Dinawan Wind Farm

Addendum Traffic Impact Assessment

Prepared for Spark Renewables Pty Ltd

Table 1.1 Response to comments from Transport for NSW (superseded by Appendix G of Amendment Report #2)

DRAWING TITLE:
STRATEGIC CONCEPT DESIGN
SISD PLAN

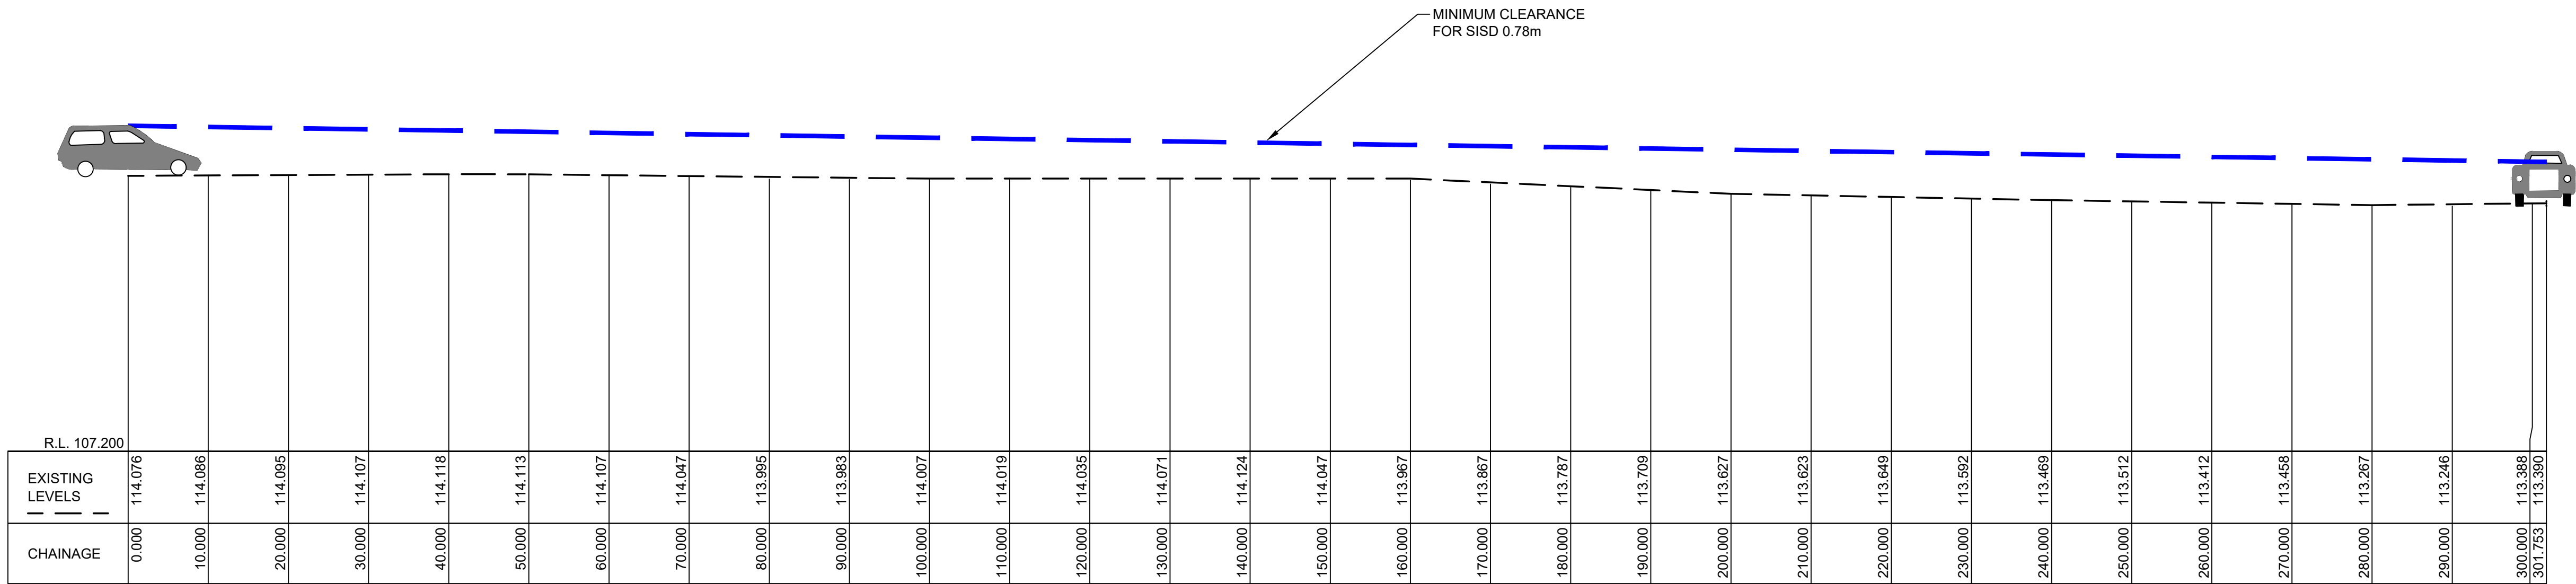
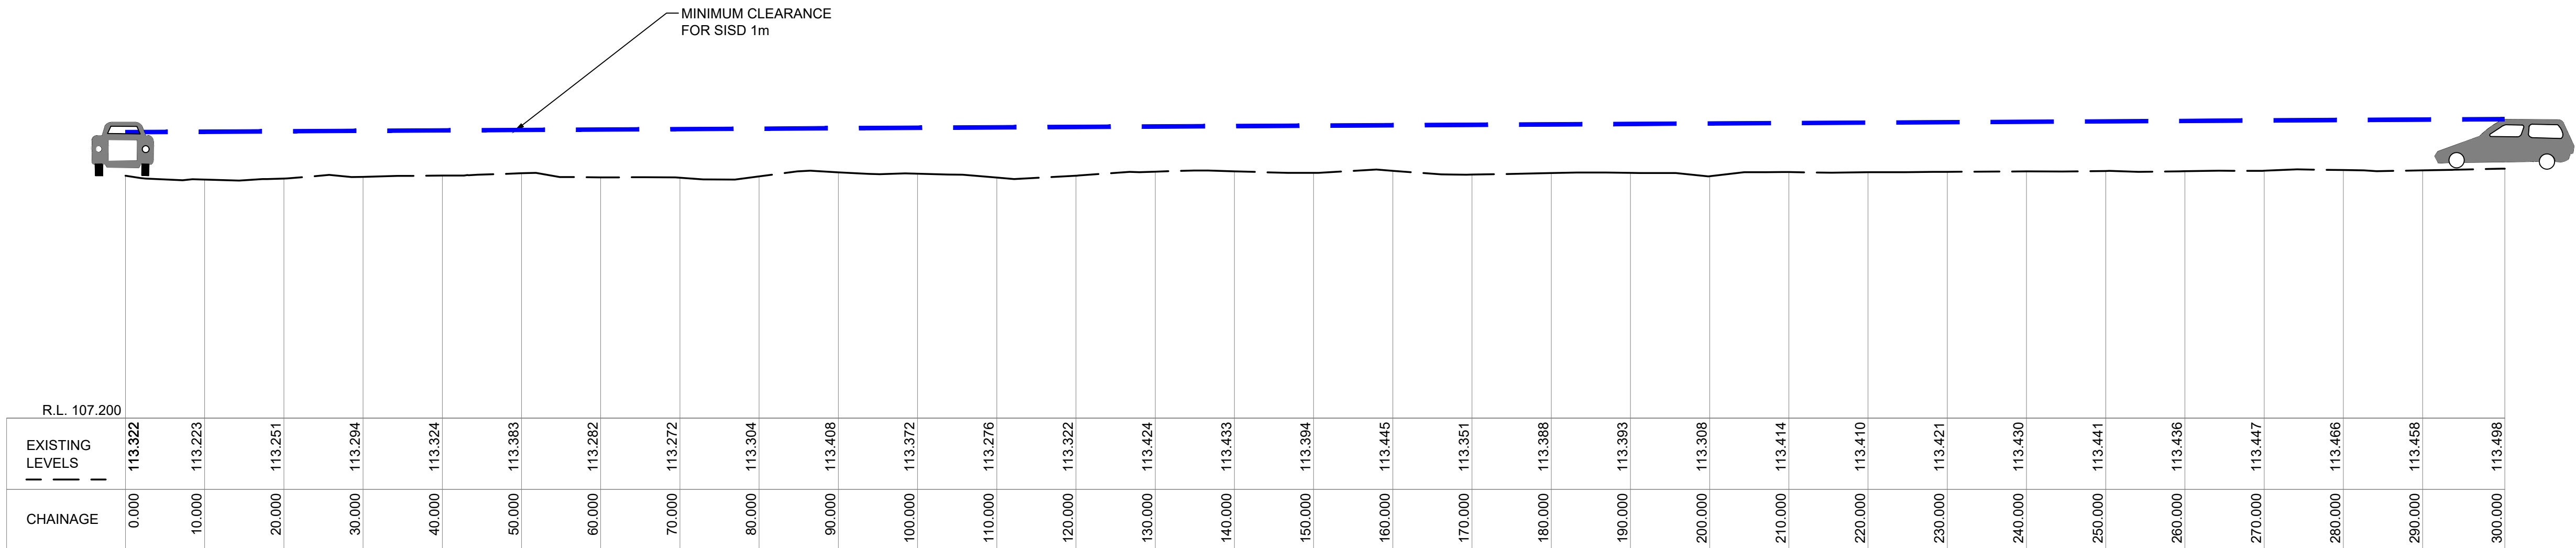
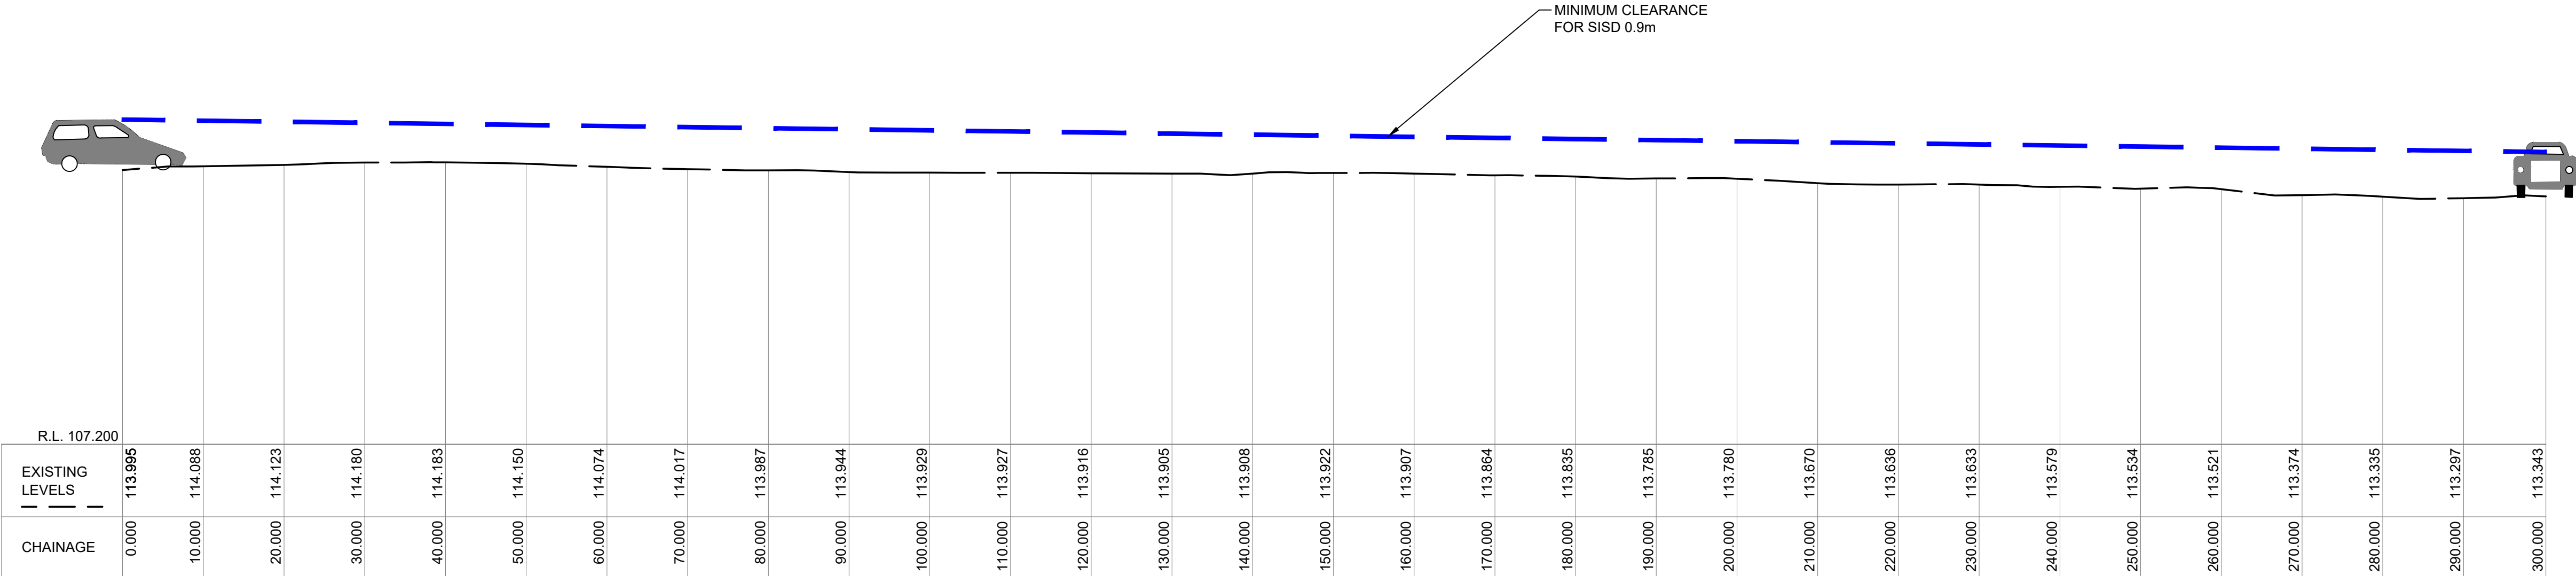
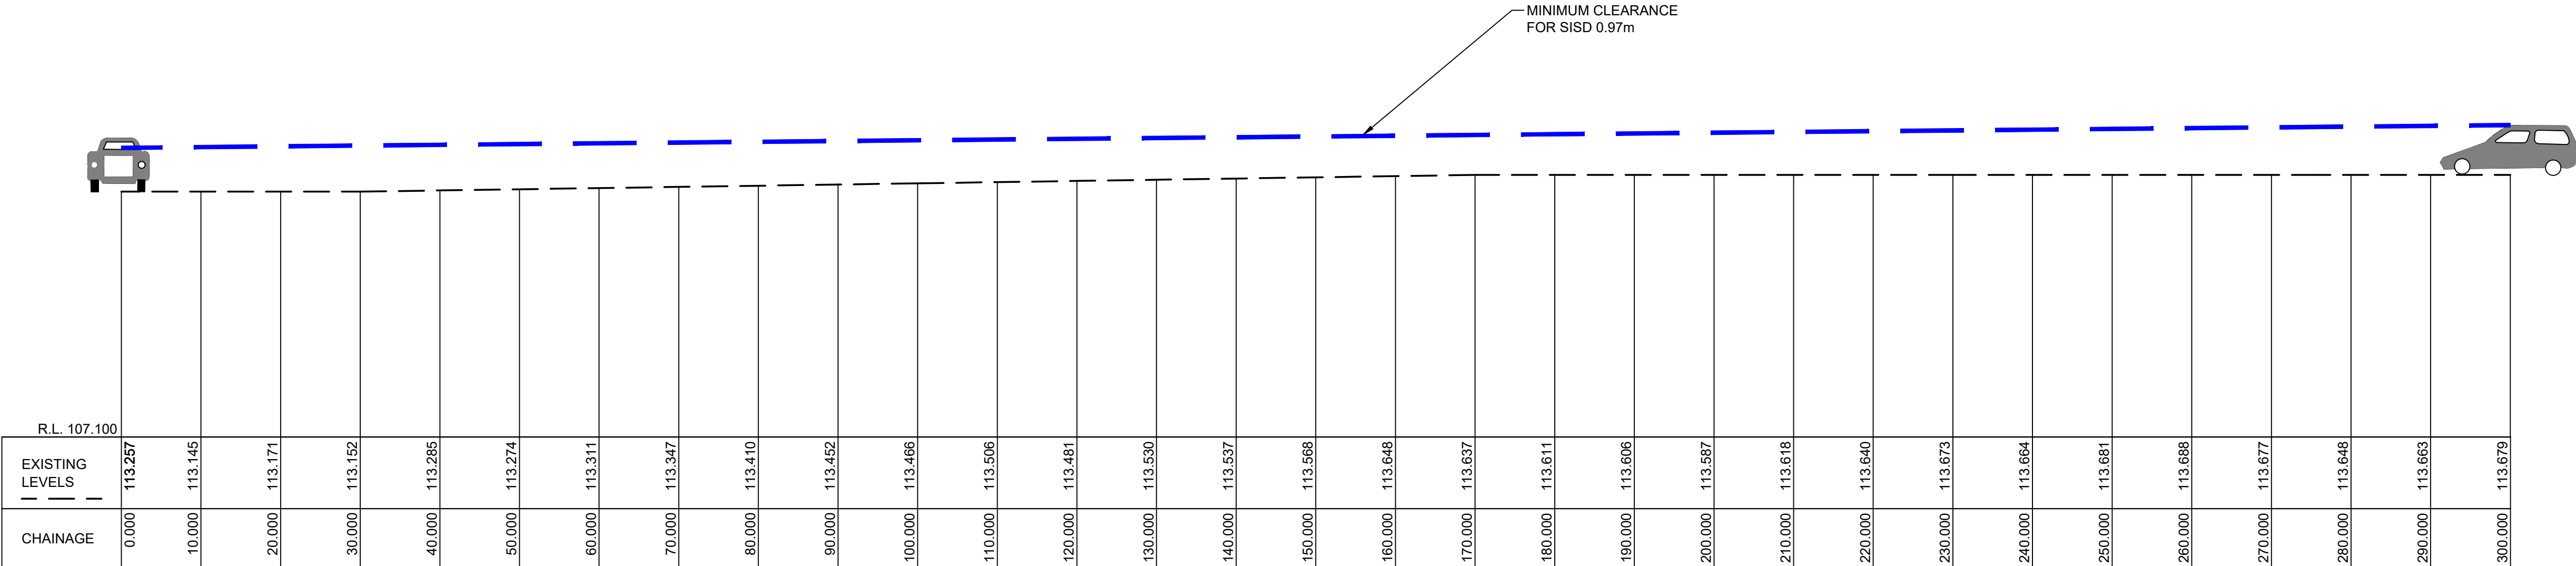
Item no.	TfNSW comment	EMM response
RFI-1 Strategic concept design revision requirements for the Kidman Way east and west access points	TfNSW requests the following information regarding the east and west access points to the Kidman Way, which have been included as part of the project revisions and within the RTS submission. The Kidman Way east and west access points did not form part of the EIS package for the Dinawan Wind Farm. Strategic concept design revision requirements for the Kidman Way east and west access points. The strategic concept designs for the Kidman Way east and west access points are to be revised to address the three points raised below. Provide a TB1 (150 mm wide broken line) at both the East and West Access. Chevron line marking in the painted medians appears to be backwards. The angle of the chevrons should align with the direction of the approaching vehicle. The CHR(S) T values is 31 m, the T value, is to be revised to align with Austroads requirements (refer to Table 7.1 within <i>Austroads Guide to Traffic Management Part 6</i>) which refers to the requirement of a 30 m or 35 m T value (i.e increments of 5 m). Note: If higher order intersection treatments are required then the points raised in points 2, 3 and 4 must be considered as part of any revisions to the strategic concept designs to capture the higher order intersection treatments at this location.	The strategic concept design has been updated (Section A.3 of Annexure A), including: • a TB1 line has been provided on both east and west access intersections • the chevron line markings have been revised • the CHR(s) T values in Table 7.1 of <i>Austroads Guide to Road Design Part 4A</i> are based on a turn lane width of 3 m. As the turn lane width is 3.5 m, the T value needs to be calculated using the formula $T = (0.33 \times (\text{design speed}) \times (\text{width of turning lane}))/3.6$ (as shown below Figure 7.2 of <i>Austroads Guide to Road Design Part 4A</i>). Using a design speed of 110 km/h, the value of T equals 35 m. Therefore, the taper has been updated to be 35 m long.

REV	DATE	COMMENT	DRAWN	REVIEWED	REV	DATE	COMMENT	DRAWN	REVIEWED
C	26/1/26	TfNSW COMMENTS	C.J.	A.U.					
B	10/4/25	TfNSW COMMENTS	C.J.	A.U.					
A	18/10/24	TfNSW COMMENTS	C.J.	A.U.					
-	8/7/24	STRATEGIC CONCEPT DESIGN	C.J.	A.U.
